ATTACHMENT A

The following demonstrates, point by point, how the design of the St. Lucie 2 Continuous Containment/Hydrogen Purge System meets the requirements of NRC's Containment Systems Branch Technical Position CSB 6-4. "Containment Purging During Normal Plant Operations" Revision 2:

FLORIDA POWER & LIGHT COMPANY
ST. LUCIE PLANT UNIT 2

CONTINUOUS CONTAINMENT/HYDROGEN
PURGE SYSTEM - P&ID

FIGURE 1

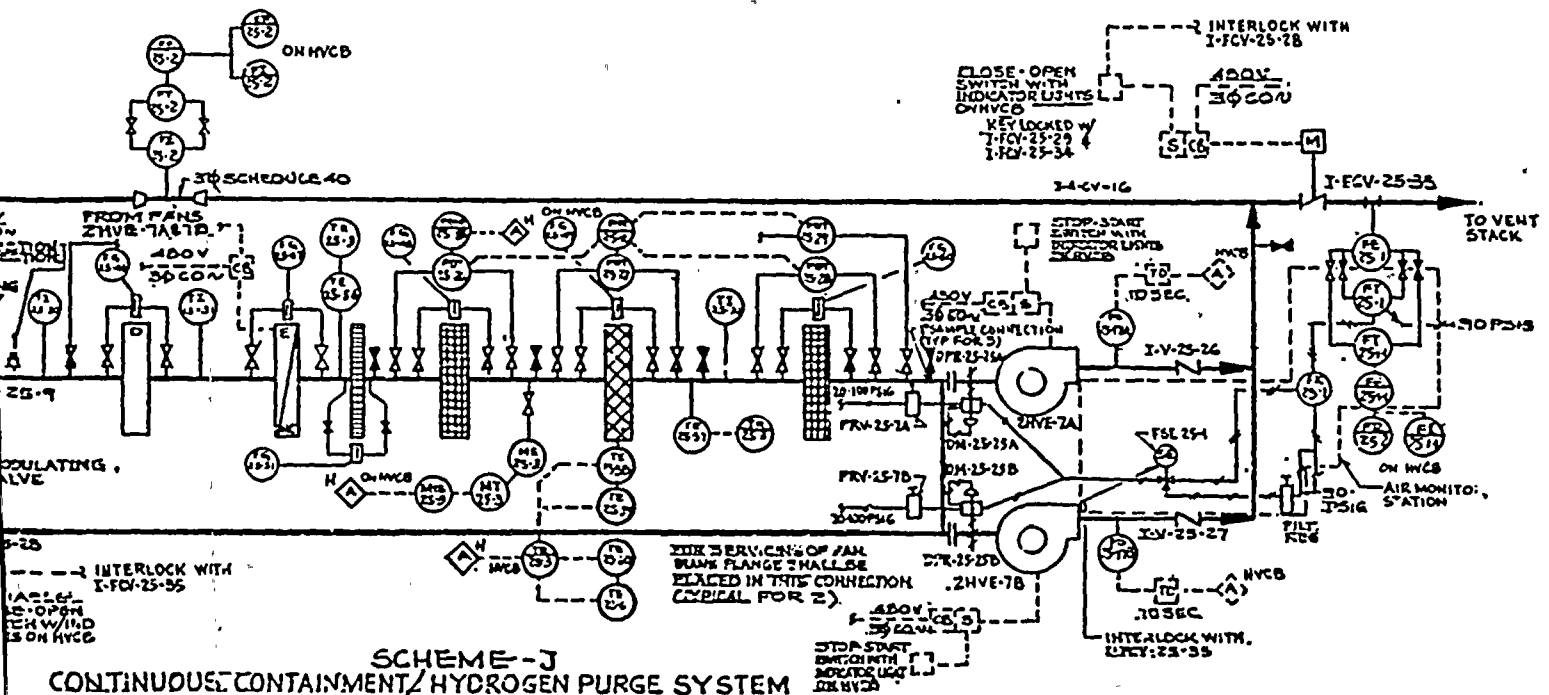
The system consists in part of two 8-inch lines penetrating containment with isolation valves inside and outside containment (Figure 1). One line provides makeup air to the containment, with air flowing through a butterfly valve, the containment penetration, and a check valve before entering the containment atmosphere. A debris screen at the outlet of the check valve prevents foreign matter from clogging the check valve and preventing its operation.

Flow from the exhaust line goes through an inlet bell and debris screen, a butterfly valve, the containment penetration, another butterfly valve, an air cleaning unit, redundant 100 percent capacity centrifugal exhaust fans and up the plant stack. Interlocks in the system prevent flow from the containment atmosphere from being released without being processed by either the Continuous Purge System air cleaning unit or by the Shield Building Ventilation System (SBVS) air cleaning units.

Debris screens are provided at the inlet bell of the exhaust line of the Continuous Purge System and at the exhaust of the makeup line of the eight inch containment purge system, in compliance with the Branch Position.
